UNITED STATES PATENT AND TRADEMARK OFFICE

APPLICATION NO.	FILING DATE	FIRST NAMED INVENTOR	ATTORNEY DOCKET NO.	CONFIRMATION NO.
10/532,427	04/22/2005	Fujita Kimura	5024-0102PUS1	1679
2292	7590	09/07/2006	EXAMINER	
BIRCH STEWART KOLASCH & BIRCH PO BOX 747 FALLS CHURCH, VA 22040-0747			LANGDON, EVAN H	
			ART UNIT	PAPER NUMBER
			3654

Office Action Summary	Application No.	Applicant(s)	
	10/532,427	KIMURA, FUJITA	
	Examiner	Art Unit	
	Evan H. Langdon	3654

Claim 8 is rejected under 35 U.S.C. 102(b) as being anticipated by JP 30-13286.

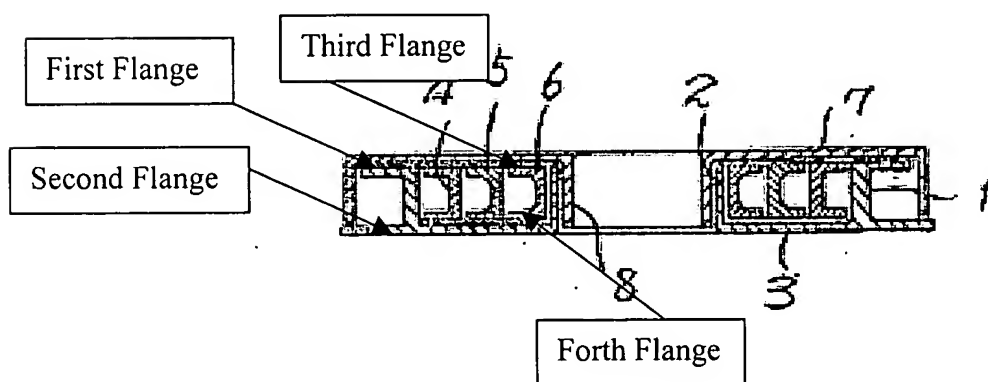
JP '286 discloses a spool comprising:

a first spool unit 3 having a first short cylindrical unit 1 around whose outer periphery a fishing line is wound, and a first flange formed on one side of the first short cylindrical unit, and a first side member forming a wall at the other side of the first short cylindrical unit and being used also as a second flange for the other side of the first short cylindrical unit;

a second spool 6 unit having a second short cylindrical unit around whose outer periphery a fishing line is wound, and a third flange formed on one side of the second short cylindrical unit, and a second side member forming a wall at the other side of the second cylindrical unit and being used also as a fourth flange for the other side of the second short cylindrical unit, wherein the second spool unit being disposed inside the first short cylindrical unit in such a fashion that a center of the second short cylindrical unit substantially coincides with a center of the first short cylindrical unit (Fig. 2); and

a support mechanism 2 comprising a support shaft integrally provided at the center of the first side member in a manner that the support shaft is orthogonal to the side member and extends toward the first flange side, and a receiver shaft integrally provided in the second side members which is orthogonal to the side member and extends toward the third flange side to be coupled with the support shaft (see below).

Claims 8, 22 and 25-27 are rejected under 35 U.S.C. 102(b) as being anticipated by JP 4-103473.

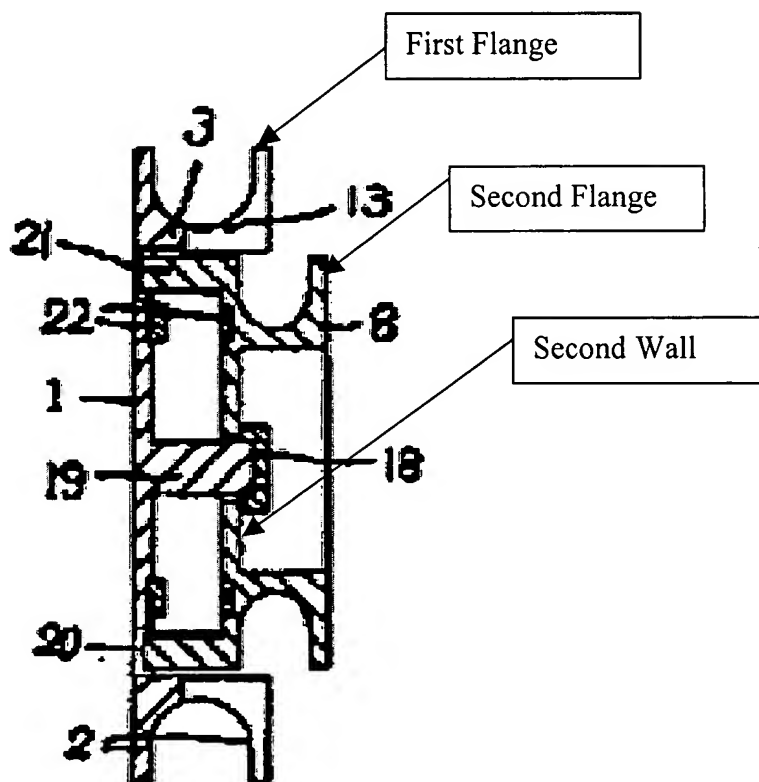
JP '473 discloses a spool comprising:

a first spool unit 2 having a first short cylindrical unit 3 around whose outer periphery a fishing line is wound, and a first flange formed on one side of the first short cylindrical unit, and a first side 1 member forming a wall at the other side of the first short cylindrical unit and being used also as a second flange for the other side of the first short cylindrical unit;

a second spool 8 unit having a second short cylindrical unit around whose outer periphery a fishing line is wound, and a third flange formed on one side of the second short cylindrical unit, and a second side member forming a wall at the other side of the second cylindrical unit and being used also as a fourth flange for the other side of the second short

cylindrical unit, wherein the second spool unit being disposed inside the first short cylindrical unit in such a fashion that a center of the second short cylindrical unit substantially coincides with a center of the first short cylindrical unit (Figures 6-8); and

a support mechanism 19 comprising a support shaft integrally provided at the center of the first side member in a manner that the support shaft is orthogonal to the side member and extends toward the first flange side, and a receiver shaft integrally provided in the second side members which is orthogonal to the side member and extends toward the third flange side to be coupled with the support shaft (see below).

In regards to claim 22, JP '473 discloses the first side member is provided with a fitting cylinder 13 extending in an axial direction of the support shaft and,

a fitting tolerance of an outer diameter of the fitting cylinder 13 and the inner diameter of the first short cylindrical unit 3 is set be such a value that the first side member is provided detachably in the first short cylindrical unit, and once being fitted, the first side member is reliably fixed to the first short cylindrical unit.

In regards to claim 25, the spool comprises a stopper 18.
